ADDENDUM NO. 001

RE: Renovations to the Nancy Pridemore Little Theater
Dobyns-Bennett High School
Kingsport, Tennessee

Project 17344

DATE: 4/23/2024

RENOVATION MAIN FLOOR PLAN AND UPPER FLOOR PLAN
 AND NOTES

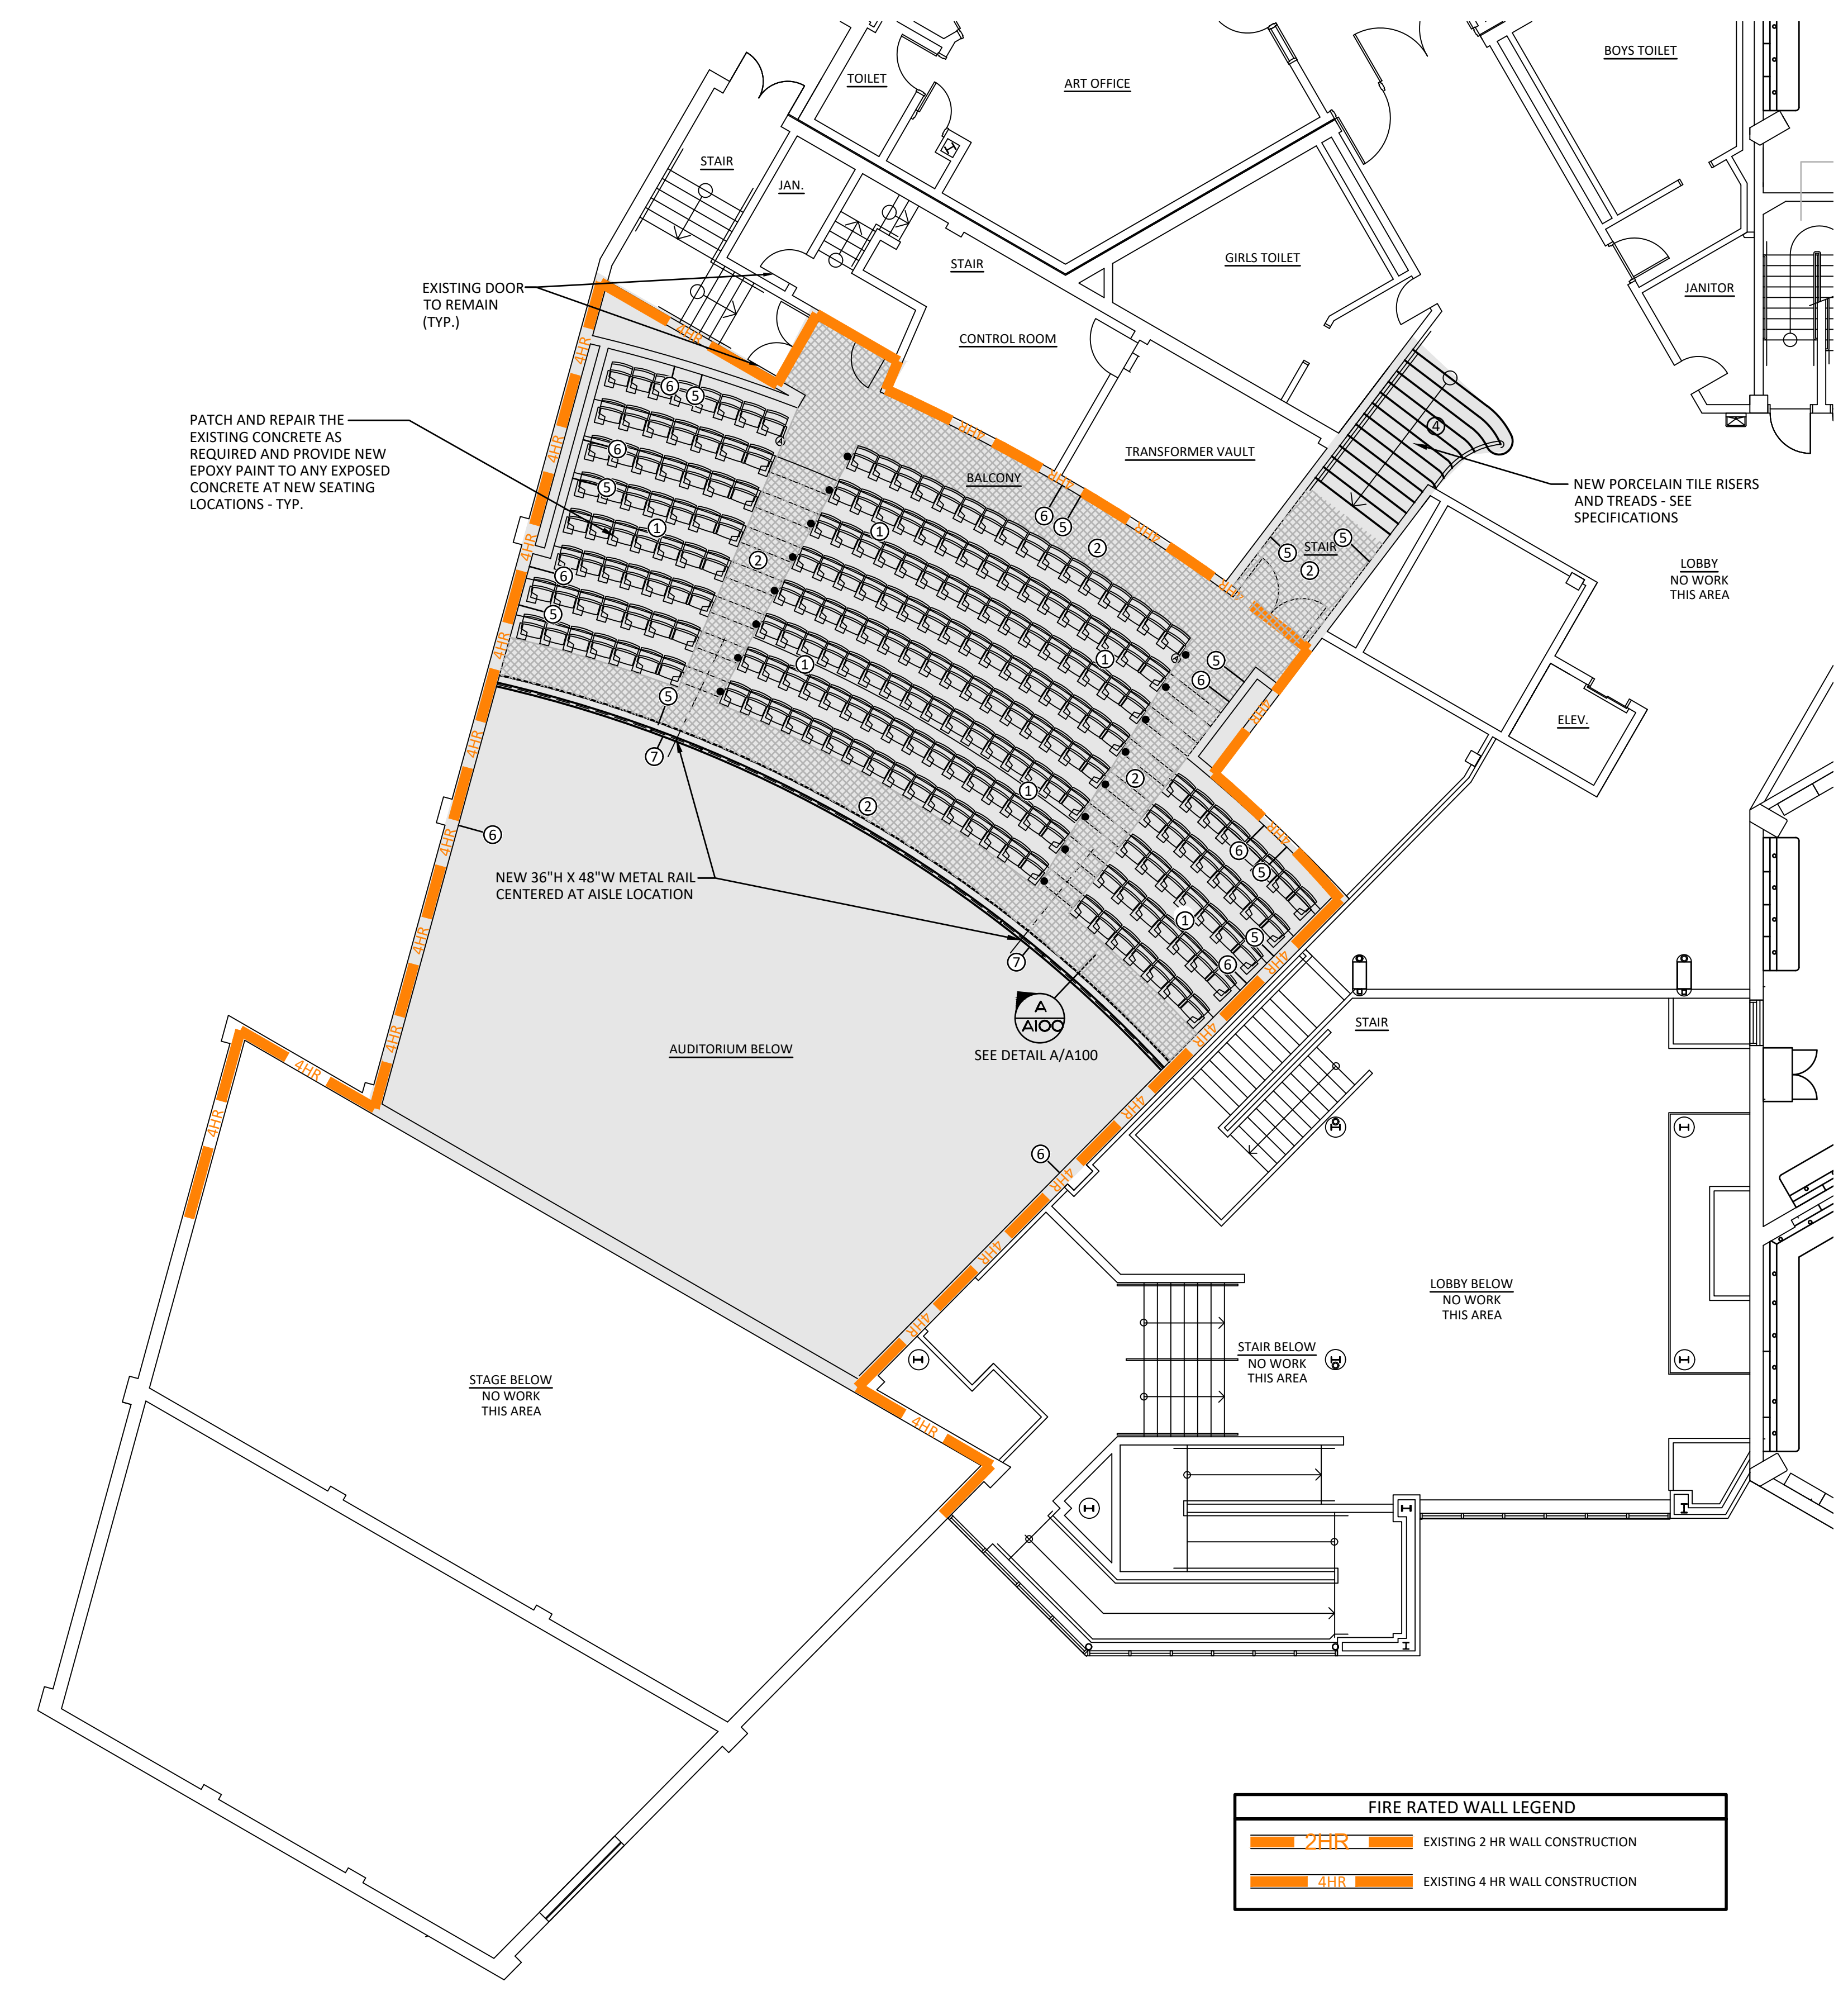
- ADD 1-4** Refer to drawing A100 RENOVATION MAIN FLOOR PLAN AND UPPER FLOOR PLAN AND NOTES. Please note that where the carpet and LVT come together that a continuous transition strip should be provided at these locations.
- ADD 1-5** Refer to drawing A100 RENOVATION MAIN FLOOR PLAN AND UPPER FLOOR PLAN AND NOTES. Please note that the existing wall mounted conduit in the space is to be painted the same color as the walls.
